XK8

TECHNICAL BULLETIN

Cooling System Bleed Lines – Correct Routing – Model Year Differences

MODEL 1997 MY-ON XK8 Range VIN 001001-ON

ILLUSTRATION 1

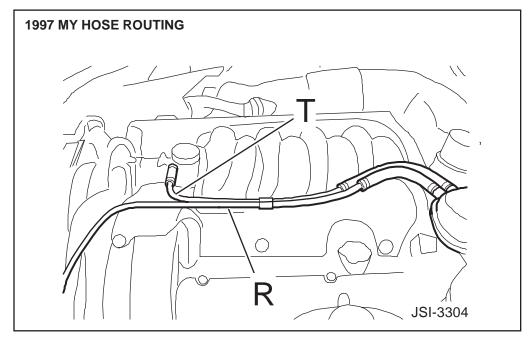
1997 Model Year Condition VIN 001001 - 018107

- Reservoir: Part No. MJA 4400AC for 1997 MY only.
- Bleed line R, Illustration 1, from radiator is connected to **front** fitting on reservoir (Illustration 1).
- Bleed Line T from thermostat is connected to **rear** fitting on reservoir.

ILLUSTRATION 2

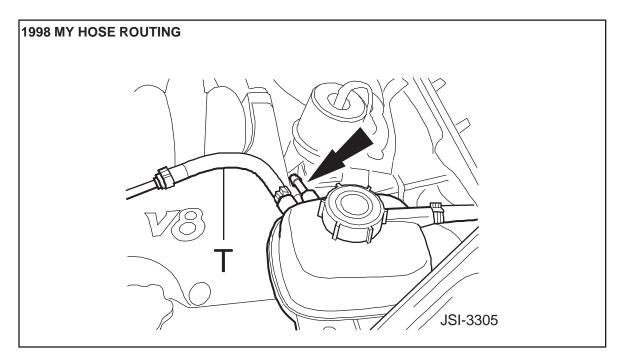
1998 Model Year Condition VIN 018108 ONWARDS

- Reservoir: Part No. changed to MJA 4400AD for 1998 MY.
- Bleed Line T from thermostat is connected to **front** fitting on the reservoir (Illustration 2).

Note: There is **no** bleed line from the radiator. This has proved to be unnecessary.

• The **rear** fitting of the reservoir (not connected) is **plugged**.

ILLUSTRATION 3

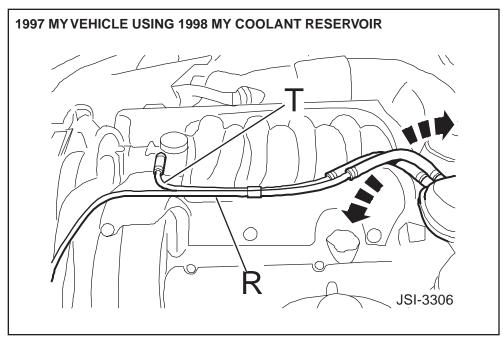
It is permissible to use the 1998 MY Reservoir Part No. MJA 4400AD on 1997 Model Year XK8 Models provided that the bleed lines are reversed at the reservoir from the original layout (Illustration 3) as follows:

- Bleed Line R from the radiator is connected to the blanked-off **rear** fitting on the Reservoir (Illustration 3). (This is satisfactory, since air will vent from the radiator by routes other than this bleed line).
- Bleed Line T from the thermostat is connected to the open **front** fitting on the Reservoir, as in Illustration 3. **THIS VENT CONNECTION IS MANDATORY. Trapped air in the cooling system cannot vent if the thermostat bleed line is connected to the plugged rear fitting.**
